CONTRACT DOCUMENT
REVISION NOTICE

Project: Fayetteville VAMC-Renovate Space for Logistics (B-1)
VA Project- 564-24-140
To: Collen Thomas
Tabitha Contreras
Re: RFI-16
Contract Document Revision Notice Number: 06
From: Jonathan Carr
Date: 3/17/2025
A/E Project Number: 19022-A
Contract For: VA Project #564-24-104

Specification Section: N/A Paragraph: N/A Drawing Reference: MD101-A, MH101-A, MP101-A & MH501-A Detail: N/A

**F4 FIRST FLOOR MECHANICAL DEMOLITION PLAN**  
1/8" = 1'-0"

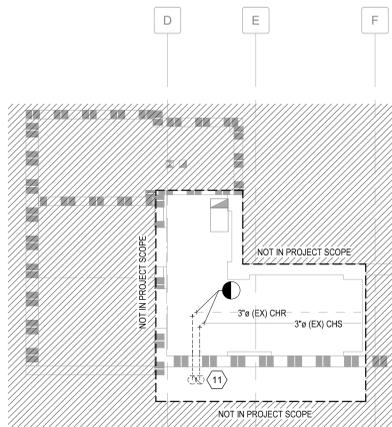
- 1. MD101-A: Basement and First Floor Mechanical Demolition Plan
a. Draws the existing medium pressure steam return piping to be rerouted and a keynote.
b. Adds note for the electrical contractor to reroute existing fire alarm speaker conduit to avoid conflict with 28x10 supply air duct.
2. MH101-A: First Floor and Loading Dock Roof Ductwork Plans
a. Adjusts the aspect ratio of penetrating duct in accordance with section 233100 par. 3.1.B.1 and adds transition.
b. Adds keynote reference to detail E8 on MH501-A.
3. MP101-A: Basement and First Floor Mechanical Piping Plans
a. Raises existing medium pressure steam return piping and adds a keynote.
4. MH501-A: Details
a. Corrects note numbering on detail E8.

- 11 PERFORM THIS WORK AFTER HOURS, FOR NO MORE THAN FOUR HOURS.
- 12 REMOVE EXISTING HORIZONTAL MEDIUM PRESSURE STEAM RETURN PIPE BETWEEN POINTS SHOWN.

- 13 ELECTRICAL CONTRACTOR TO REROUTE FIRE ALARM CONDUIT FROM EXISTING FIRE ALARM SPEAKER JUNCTION BOXES AS NEEDED TO MAINTAIN A MINIMUM CLEARANCE OF 12 INCHES BELOW THE 2" INSULATED SW DUCT. COORDINATE ROUTING WITH MECHANICAL AND OTHER TRADES TO AVOID CONFLICTS.

**F4 FIRST FLOOR DUCTWORK PLAN**  
1/8" = 1'-0"

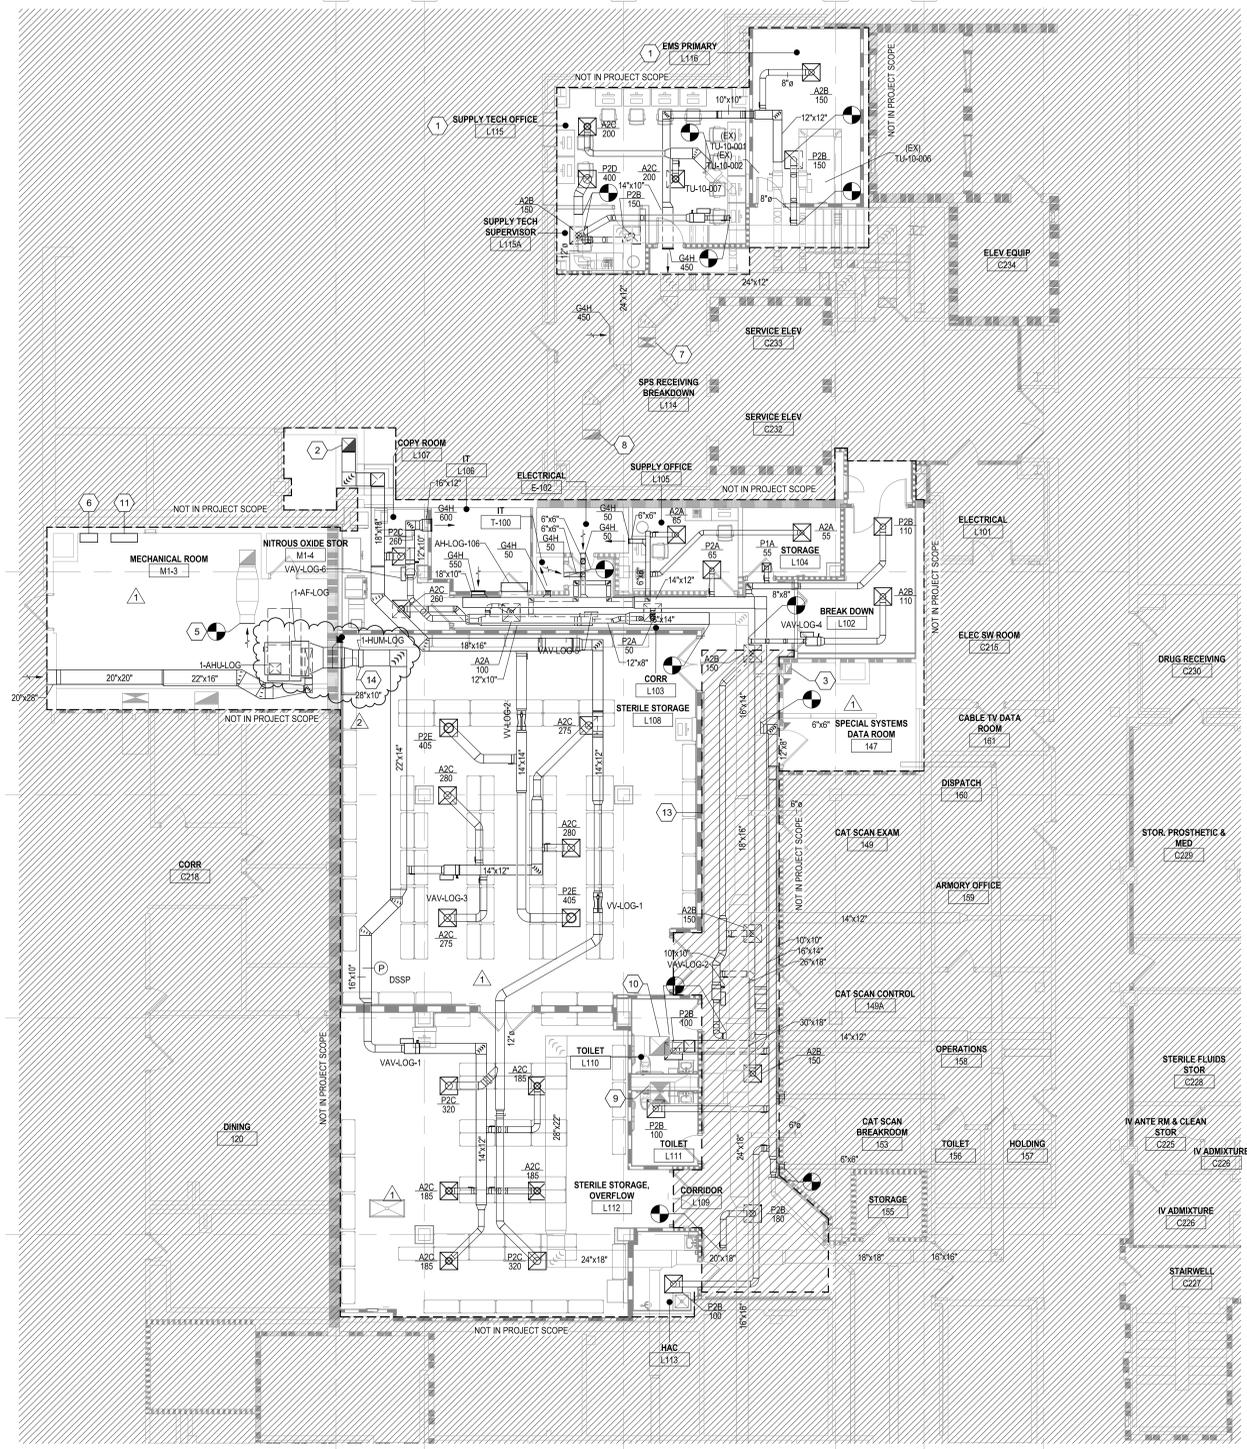
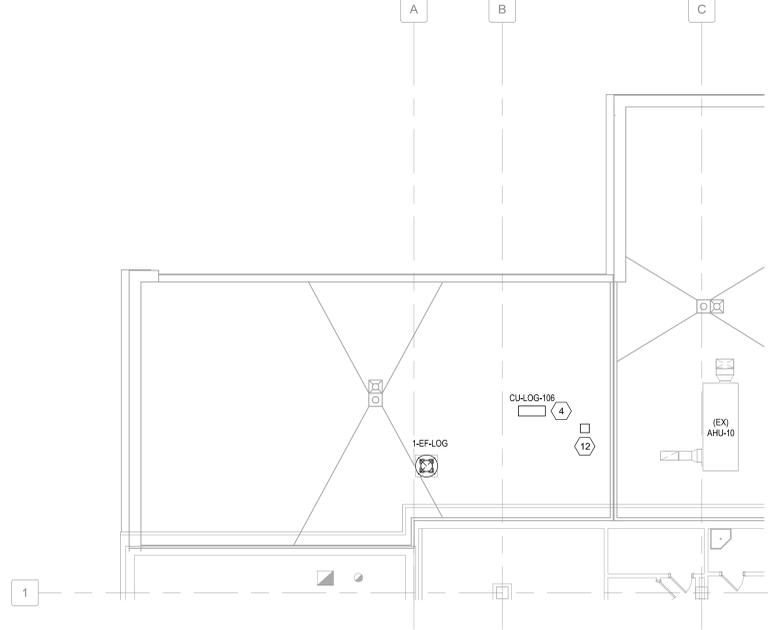
CDRN-06 responds to RFI-16 by adjusting the aspect ratio of the supply duct penetrating the wall between Mechanical Room M1-3 and Sterile Storage L108, raising the conflicting medium pressure steam condensate pipe and moving conduit to 12" below insulated 28"x10" duct to penetrate the wall with the bottom of insulated duct at 8'-3" above the mechanical room floor, adding a transition to 22"x14" with B.O.D. at 8'-6" A.F.F. after the wall penetration and before the humidifier, and placing a keynote reference to the Duct Mounted Humidifier detail. Adjust notes on Detail E8 on sheet M501. Electrical contractor to reroute existing fire alarm conduit from existing fire alarm speaker junction boxes as needed to maintain a minimum clearance of twelve inches below the 28x10 supply air duct.
